**From:** Rick Rutledge [mailto:rrutledge@alleecorp.com]  
**Sent:** Monday, August 18, 2008 5:06 PM  
**To:** zzMSHA-Standards - Comments to Fed Reg Group; Silvey, Patricia - MSHA  
**Cc:** 'Leonard Urtso'  
**Subject:** Comments on Refuge Alternatives for underground coal mines  
**Importance:** High

# Evaluation of MSHA Proposed Mine Shelter Rules

This report is directed to MSHA concerning the new MSHA DOL report on the Refuge Alternatives for Underground Coal Mines; Proposed Rule as presented in their printed report and also area discussed at the open hearing in Charleston on July 31, 2008.

**Section 7.504 (a)(4) Towing/Moving the Shelter Underground**

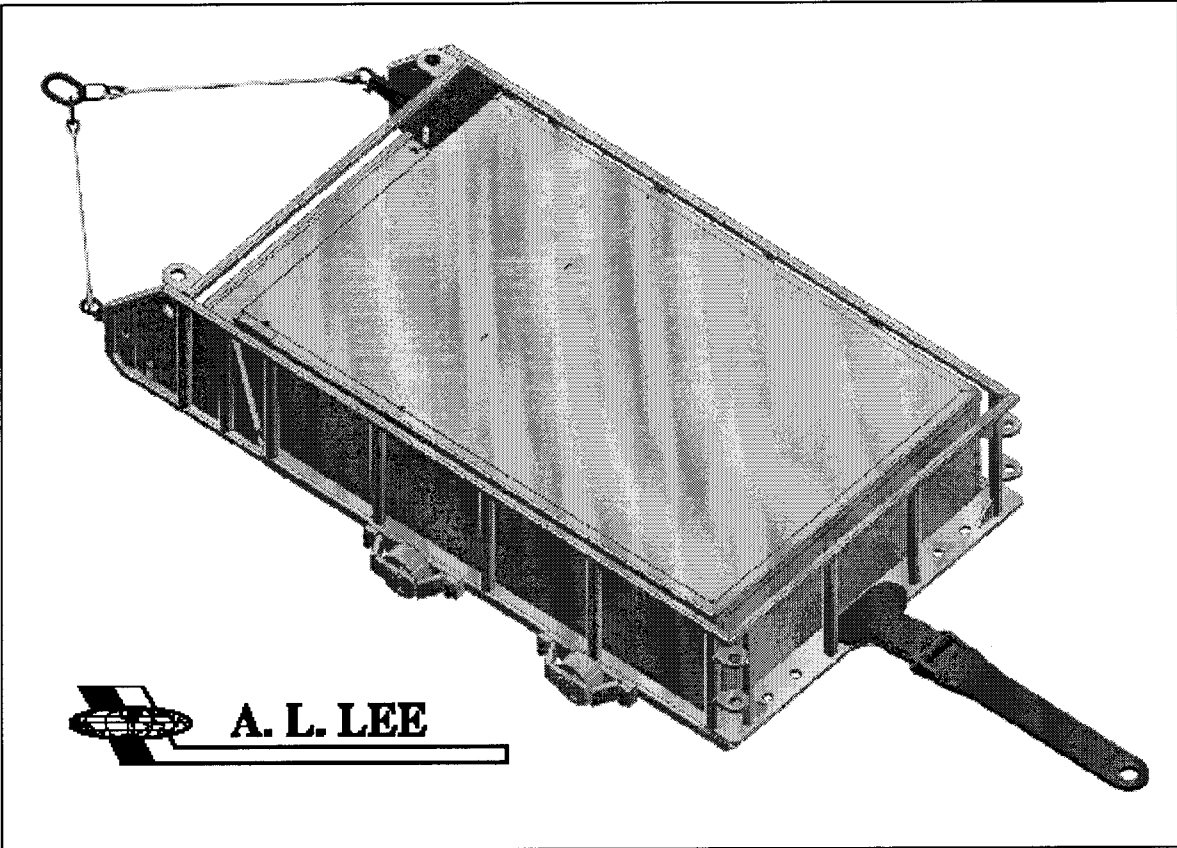
This section states “The refuge alternative should be designed with proper connections and devices to eliminate or reduce the use of chains, ropes and slings.” The preferred method taught at the mine site by our trainers for units equipped with wheels is the use of the towbar, which can only be used from the rear. The use of a towbar in the front would cause us two problems; 1) the towbar itself would get in the way of the deployment door in the case of an emergency and 2) towing from the front increases the likelihood of damage to the deployment door area. However, the mines have requested the ability to tow from the front under certain circumstances. To accommodate their need, we have designed a dedicated cable system expressly for the purpose of towing from the front. Though discouraged, this cable system will allow the mine to tow from the front if absolutely necessary and only when towing with the towbar is not an option. Please note that the optional wheels are depicted.
